ADDENDUM NO. 1

PROJECT NAME: *Marianna Iralena Hotel*

PROJECT NUMBER: *FLORIDA COMMERCE: CDBG-DR M0047*
DHM PROJECT NUMBER: *MAR22HR*

1. This Addendum is posted on the OneDrive link under Addendum & RFIs > Addendum #1. The OneDrive link is the original link containing the Plans & Specifications. If you do not have the link, please request the link from martivickery@melvineng.com.
2. RFI are listed on the OneDrive link and are constantly updated.
3. A revised Bid Tabulation Detail sheet C-410 Page 2 of 6 is attached and shall be used with the bid submittal.
4. A Conflict of Interest form was missing from the specs and is attached.
5. The asbestos and lead paint report is attached for reference. All asbestos has been removed. Lead paint does remain in the building and the contractor shall mitigate lead paint issues in accordance with local, state and federal requirements.
6. Attached are Donofro Addendum 1 items.
7. Attached are revised plan sheets A-0.1, A-1.1, A-1.2, A-1.4, A-2.0, A-3.0 and A-8.0.

SHEET No.
A-3.0

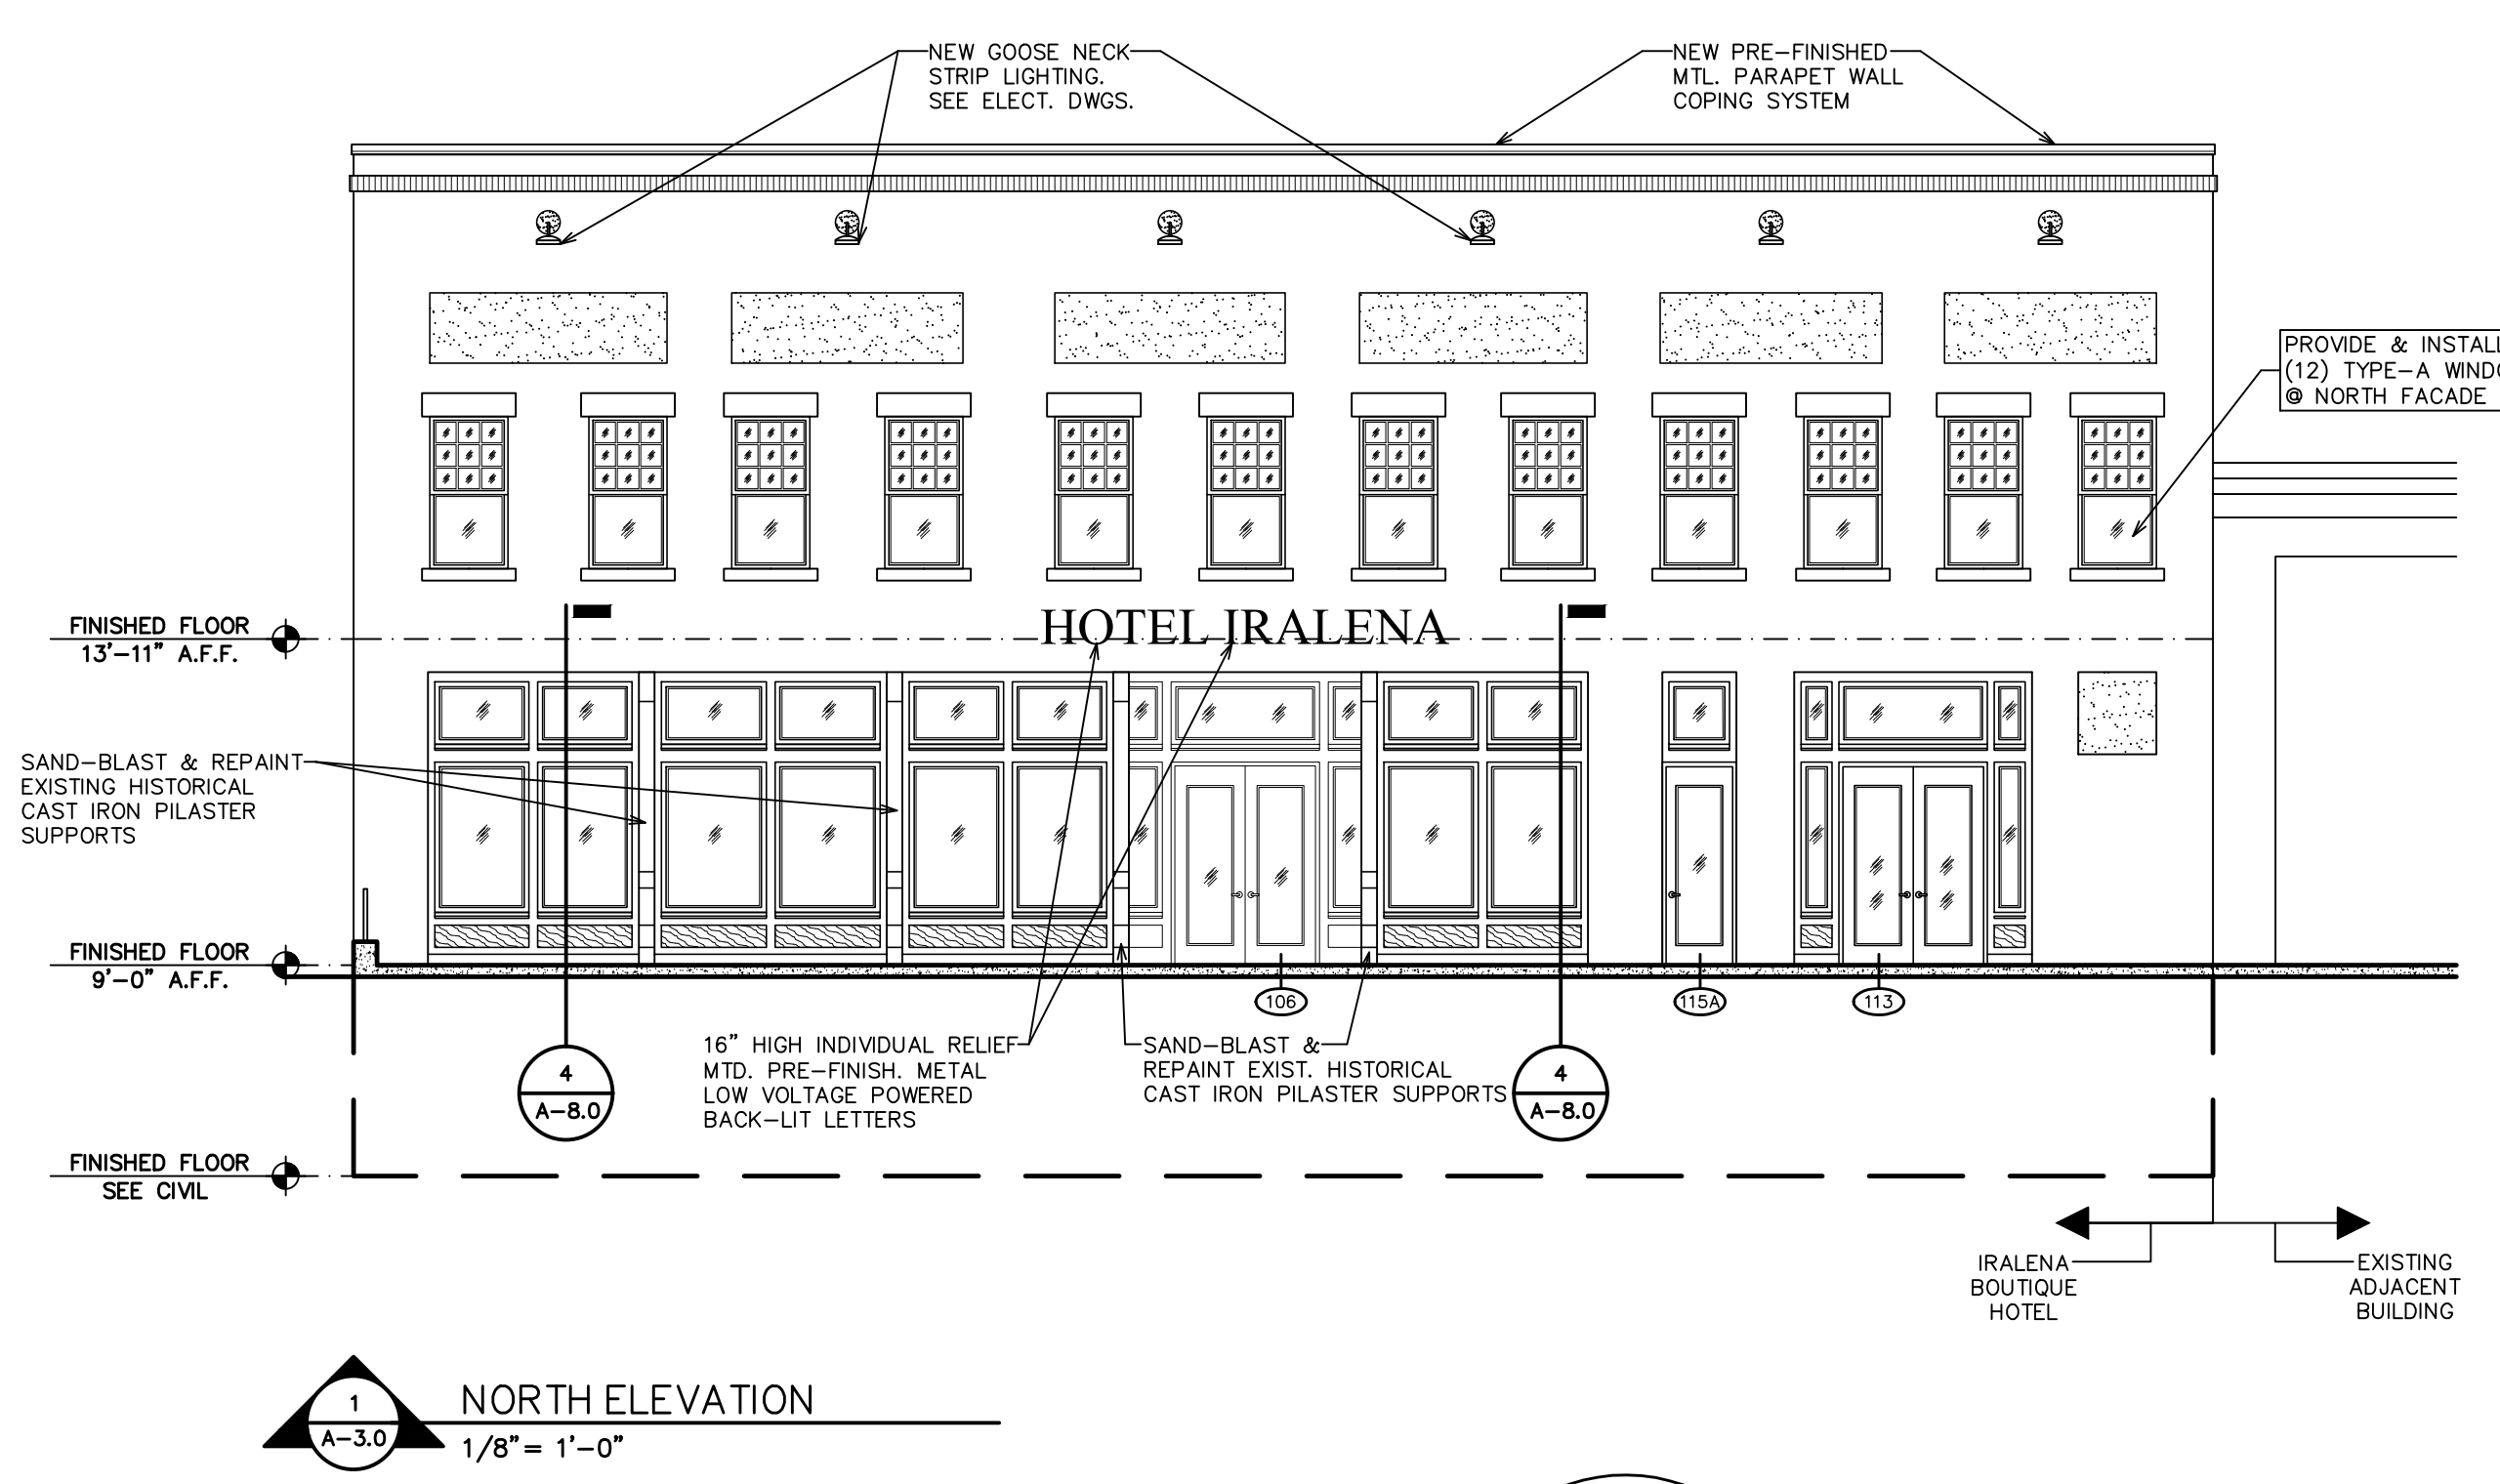
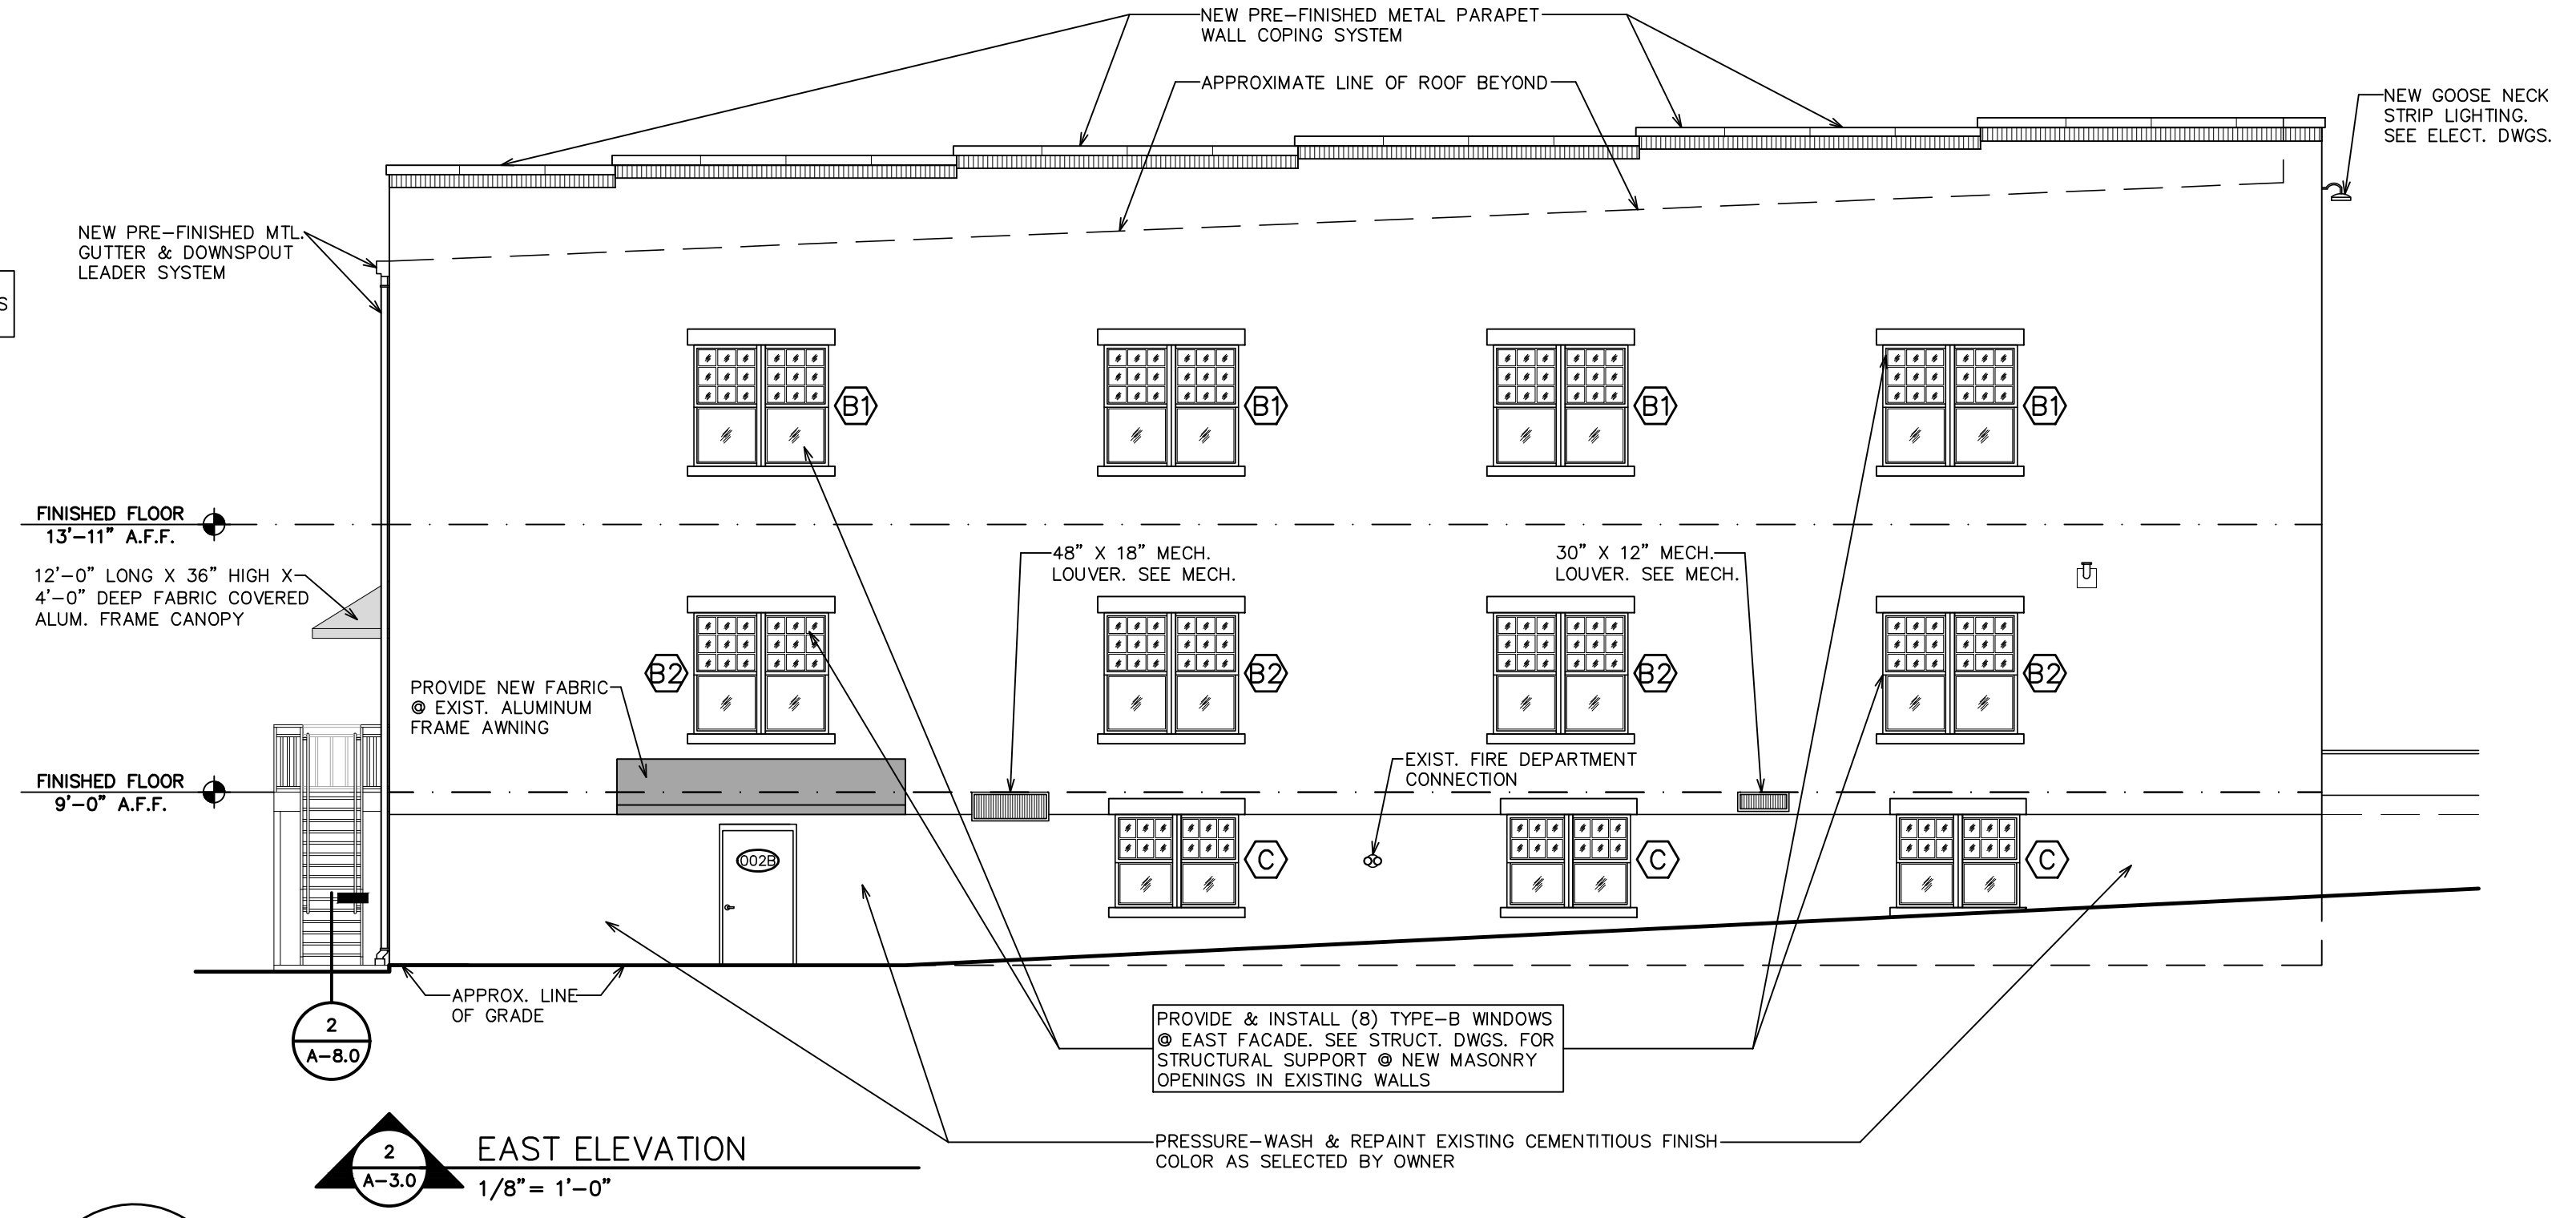
<p>Item 4: 5-04-2026</p>	<p>Refer to Architectural Sheets A- 2.0 and A -2.1</p> <p>ADD add the following Note.</p> <p>EXISTING INTERIOR BRICK SURFACES - All existing interior brick surfaces to remain and to remain exposed and shall receive a minimum two coat application of clear, matte, water based polyurethane sealer. Application of the sealer to achieve a natural, matte finish and to exhibit no visible sheen nor yellowing. Contractor to apply product to a 3' x 3' (minimum) test area for owner review and approval prior to full application. All surfaces to receive sealer application shall be clean, dry and free of dust, loose mortar, and efflorescence prior to sealer application. See revised sheet A-2.0 and A-2.1 included with this addendum.</p>
<p>Item 5: 5-04-2026</p>	<p>Refer to Shet A-3.0</p> <p>ADD the following note:</p> <p>The entirety of the existing building exterior to be painted including but not limited to the existing face brick veneer, the cement stucco, concrete window headers, and C.I. pilasters using KEIM Paints. For painting the existing brick veneer and stucco surfaces use a minimum of two coats of KEIM Granital Exterior Mineral Potassium Silicate Paint at an application rate of 250 to 300 sf per gallon. Prior to paint application, existing surfaces to be repainted shall be thoroughly cleaned, dry and prepared as per KEIM Paint Manufacturer's recommendation. See revised sheet A-3.0 included with this addendum.</p>
